Service Bulletin

Repair procedure to additional wires protection

SB-ASTM-CTSW-16**SB-ASTM-CTLS-17****SB-CTLS-ELA-001****SB-ASTM-MC_-04****SB-LTUL-CTSW-15****SB-LTUL-CTLS-14**

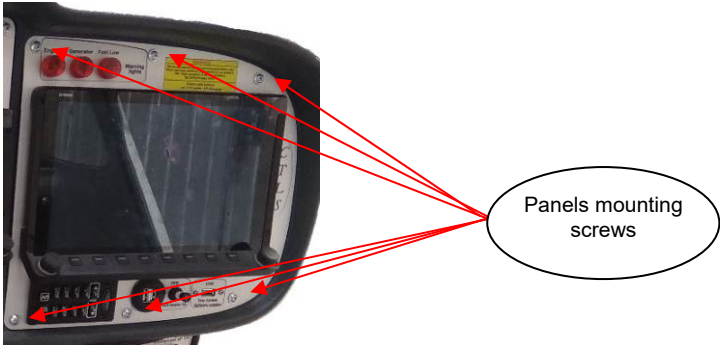
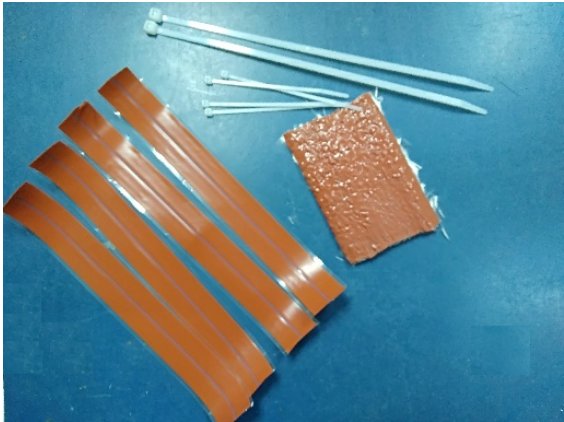
Step	Action	Reference
1	<p>Remove Panel Right section. Unscrew panel mounting screws.</p> 	
2	<p>Open additional wires protection set.</p> 	
3	<p>Pull out the wires as much as possible.</p>

4

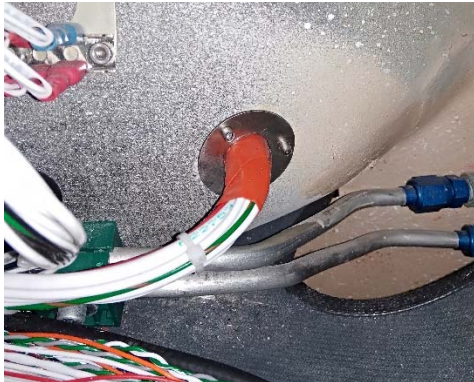
Remove the protective film from pyrosil tape. Wind the pyrosil tape around the wires*.

*Installation: Stretch tape during installation using at least a 50% overlap. For best results, use on clean, dry surfaces free from dirt and oil.

The protective layer must be at least 5 layers.

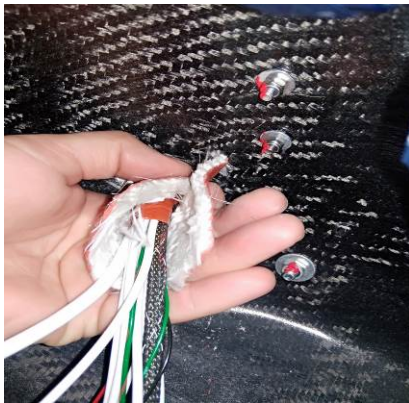
Wrap fire protection hose around flange and wires. Tighten TY-wraps around flange and wires.
